**SIB 17 01 22**

SERVICE ACTION: INSPECT AND MODIFY OPTIONAL ACCESSORY COOLER GUARD

This Service Information Bulletin replaces SIB 17 01 22 **dated February 2022**.

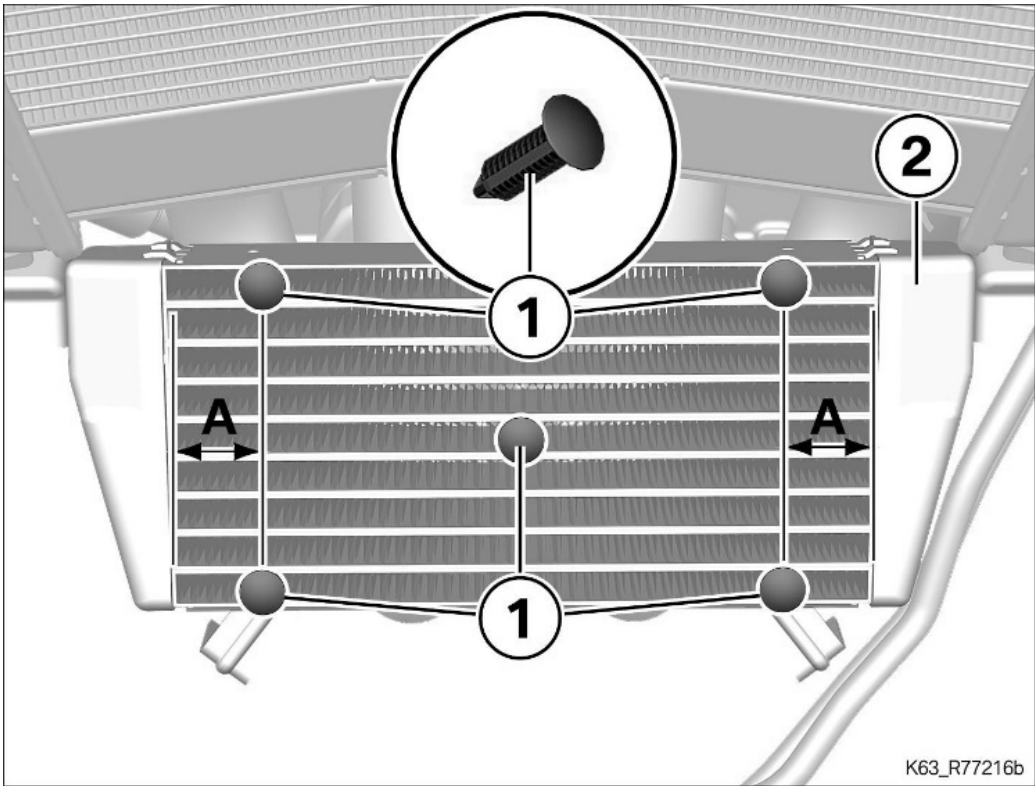
Installation of the accessory oil cooler guard from the BMW Motorrad Special Accessories Catalog may result in chafe marks on the cooler.

New installation instructions require use of special spacers to prevent chafing marks on the oil cooler.

If the accessory oil cooler guard is installed, please reinstall it with five (5) spacers, part number below. Follow instructions “77 14 006 – Installing the radiator protection” in AIR, which were updated in February 2022.

Once the oil cooler guard is re-installed with spacers, please confirm that the guard is not touching the oil cooler.
